Work Order ID 64659

Item Name: Blower Motor Assembly

DART SERVICE INSTRUCTION

TO AMEND INSTALLATION INSTRUCTIONS IIN-D206-746 REV. A

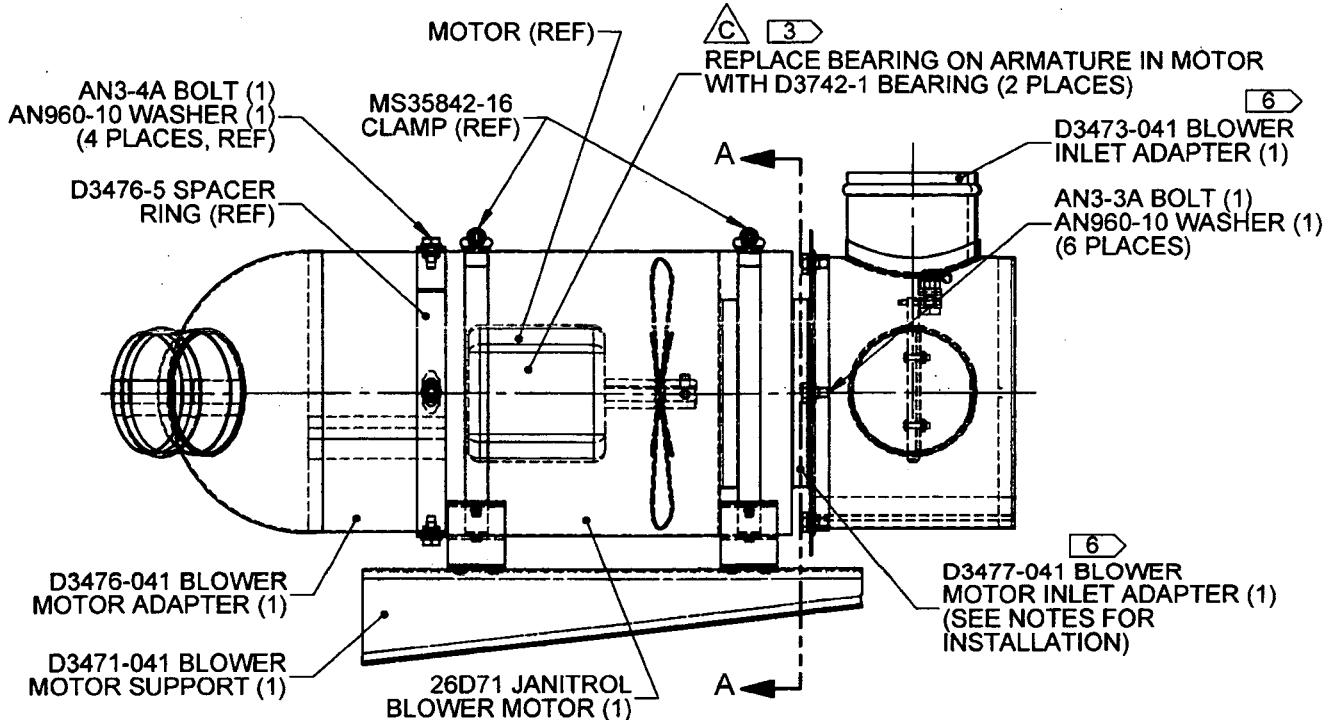
The Parts List of Installation Instructions IIN-D206-746 Rev. A should be amended as follows:

Furthermore, any mention of "Blower Motor Assembly" appearing in Installation Instructions IIN-D206-746 Rev. A, and Installation Drawing D206-746 Rev. A, should be replaced by D206-746-043 Blower Motor Assembly.

D206-746-043 BLOWER MOTOR ASSEMBLY

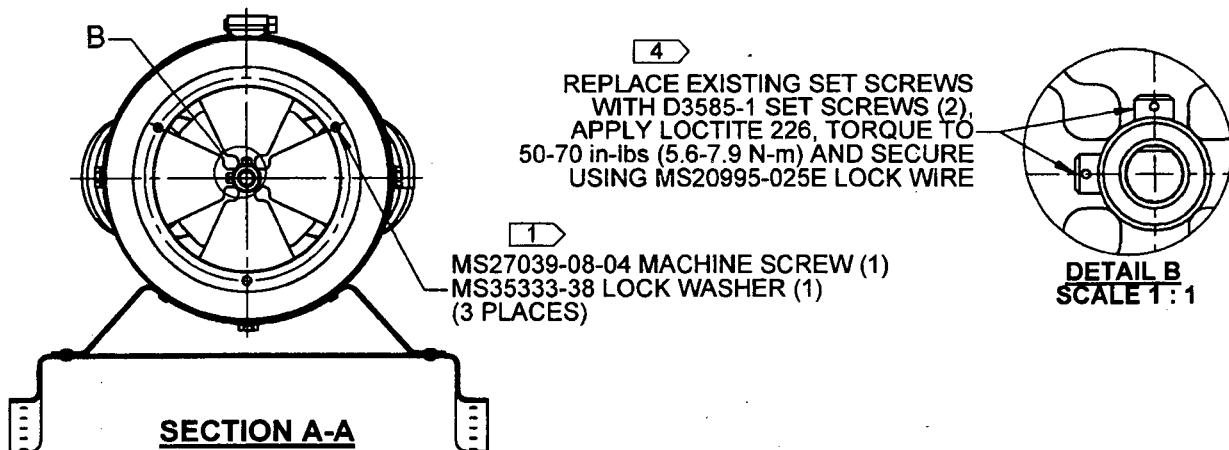
C	ADD D3742-1 BEARING; UPDATE FORMAT	PH	08.01.20
B	ADD D3585-1 & DETAIL B	MB	07.01.02
A	NEW ISSUE	MB	06.08.09
REV.	DESCRIPTION	BY	DATE
DESIGN	b	DART AEROSPACE LTD HAWKESBURY, ONTARIO, CANADA	
DRAWN	PH		
CHECKED	b		
MFG. APPR.	E		
APPROVED			
DE APPR.			
DRAWING NO.	DSI 9341		REV. C
DATE	08.01.20		SHEET 1 OF 2
TITLE	SCALE		
BLOWER MOTOR ASSEMBLY NTS			
COPYRIGHT © 2006 BY DART AEROSPACE LTD THIS DOCUMENT IS PRIVATE AND CONFIDENTIAL AND IS SUPPLIED ON THE EXPRESS CONDITION THAT IT IS NOT TO BE USED FOR ANY PURPOSE OR COPIED OR COMMUNICATED TO ANY OTHER PERSON WITHOUT WRITTEN PERMISSION FROM DART AEROSPACE LTD.

- 1) ON 26D71 BLOWER MOTOR, REMOVE EXISTING MACHINE SCREWS (3), LOCK WASHERS (3) AND EXISTING ADAPTER (1).
- 2) REMOVE MOTOR AND RETAIN HARDWARE
- 3) REPLACE BEARINGS WITH D3742-1 BEARINGS (2 PLACES) \triangle
- 4) REPLACE SET SCREWS WITH D3585-1 SET SCREWS (2 PLACES)
- 5) RE-INSTALL MOTOR WITH HARDWARE REMOVED AT STEP 2
- 6) REPLACE ADAPTER WITH D3477-041 BLOWER INLET ADAPTER. USE HARDWARE REMOVED AT STEP 1 TO SECURE D3473-041/D3477-041 BLOWER INLET ADAPTER TO 26D71 JANITROL BLOWER MOTOR.
- 7) D206-746-043 IS SUPPLIED TO CUSTOMER PRE-ASSEMBLED
